**City of Portland, Maine – Building or Use Permit Application** 389 Congress Street, 04101, Tel: (207) 874-8703, FAX: 874-8716

REASON FOR PERMIT: Build New deck on 2<sup>nd</sup> floor 12'x12' - remove window - stall door

# BUILDING PERMIT REPORT

109 DARTMOUTH  
WALL SECTION

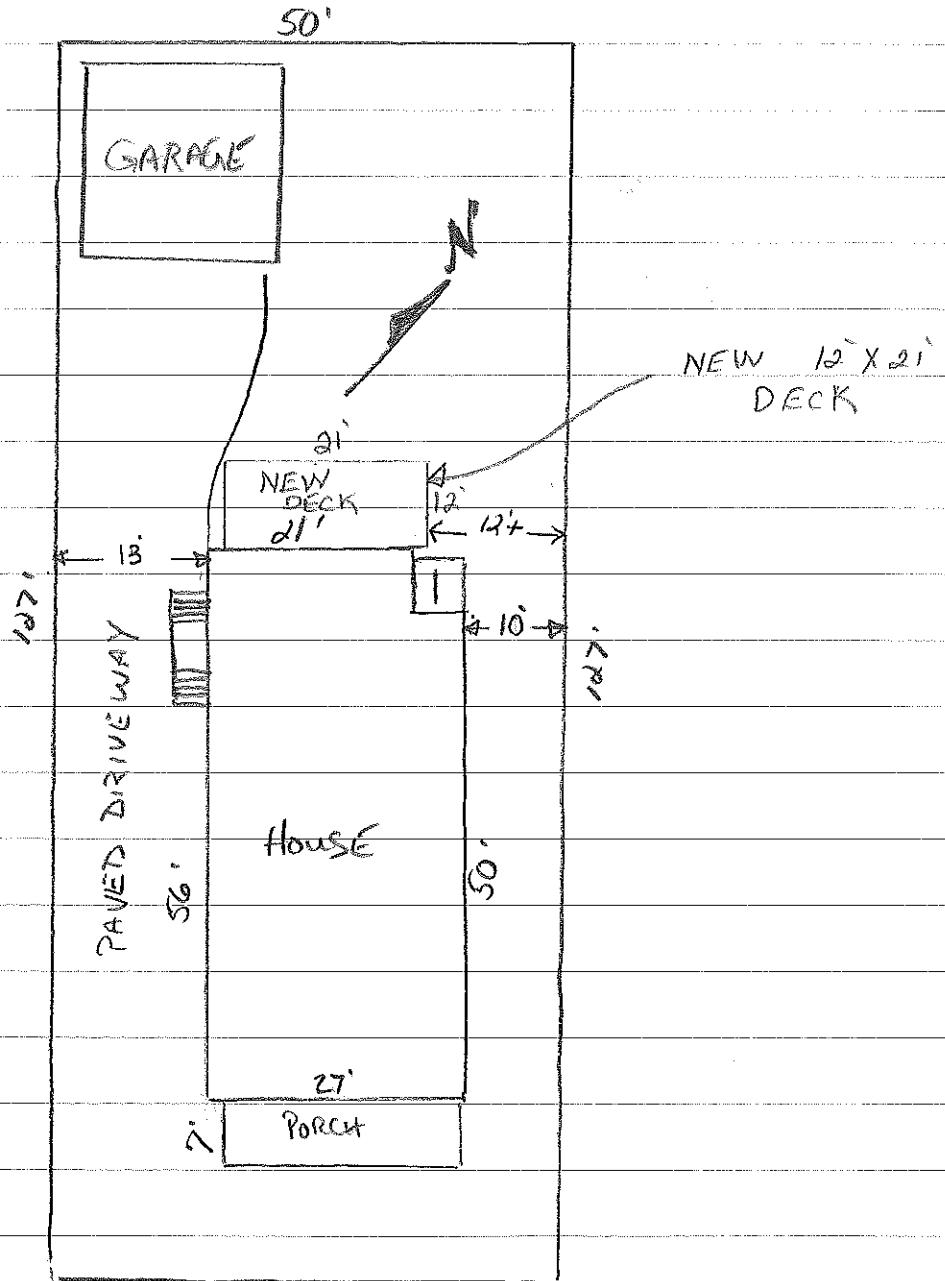
- \*31. The Footing and Sono Tube must be anchored together
- 32. Your plans to install a new door by removing a window requires a header design - Please submit This before work begins

REMOVE EXISTING WINDOW  
INSTALL NEW DOOR

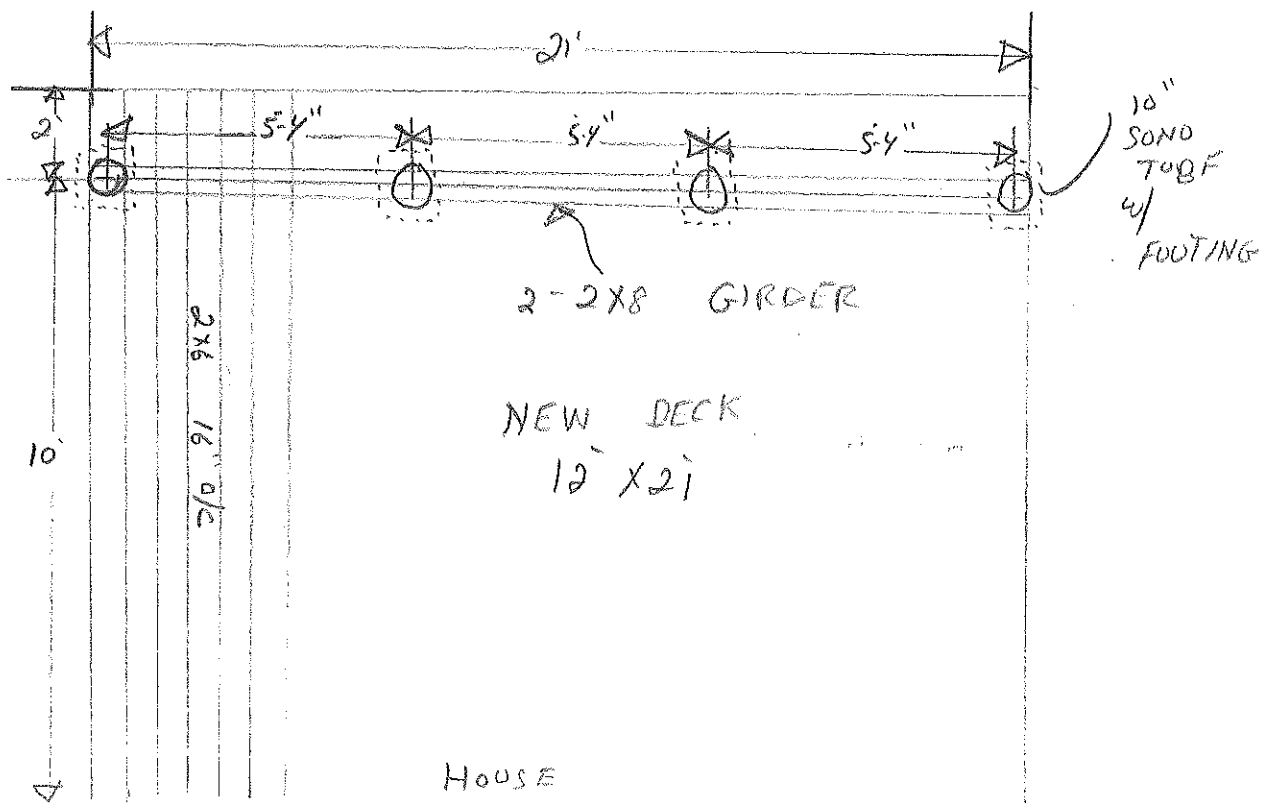
- \*29. 2x6 @ 16" O.C. with a 10' span will NOT meet The requirements of the PTLR bldg. Code. 2x8 @ 16" O.C. would meet The Code requirements
- \*30. The proposed 4x4 post must be fasten to The 10" sonotubes
